City of Alexandria, Virginia

MEMORANDUM

SUBJECT: ISSUES REGARDING THE SAP AND MAP AMENDMENTS
701 N. HENRY STREET (DSUP2019-00028)

Re: 701 North Henry Street

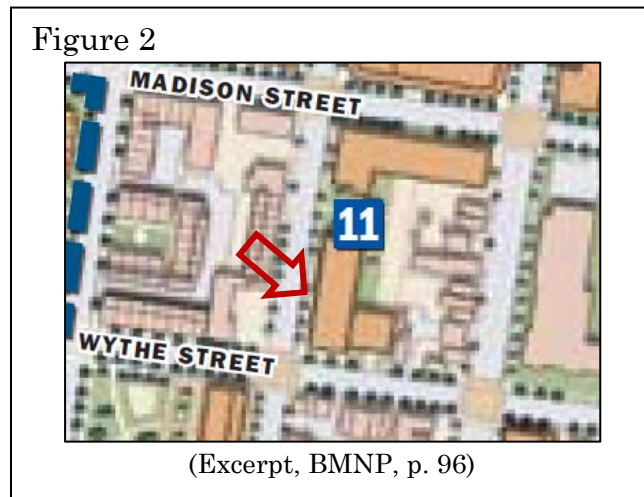
The applicant's proposed heights and setbacks are inconsistent with the Small Area Plan. As shown in Figure 1, the Braddock Metro Neighborhood Plan (BMNP) limits the height of this site to 30' for the eastern half of the site except a 40' portion adjacent to Wythe—consistent with adjoining Parker-

Gray homes that are two stories tall. The BMNP permits 50' only directly along Henry Street. In other words, as shown in Figure 2, the BMNP provided for an L-shaped building that provides appropriate setbacks and transitions from the adjoining two-story historic homes. The applicant's five-story C-shaped proposal is inconsistent with the BMNP, exceeding the "maximum height[s]" of 30' and 40' for most of the site that are necessary to "ensure transitions in scale between the two and three-story fabric" of the adjoining homes.¹

To solve these issues, we ask you to add limits sufficient to protect the history, scale, and character of our neighborhood. We ask you to ensure that the project complies with the BMNP's limits and principles and follows the Design Principles and Design Guidelines. Please do not approve this project without adding appropriate height and setback limits.

It is imperative to limit the height of the eastern half of the property to 30' (except the 40' portion directly adjacent to Wythe Street), as provided in the BMNP. We recognize that the BMNP envisioned a 50' portion along Henry Street only, running back less than halfway across the property. *We do not believe five stories are appropriate anywhere on the property*—particularly because surrounding development in the area has been four stories (e.g., the Ramsey Homes and
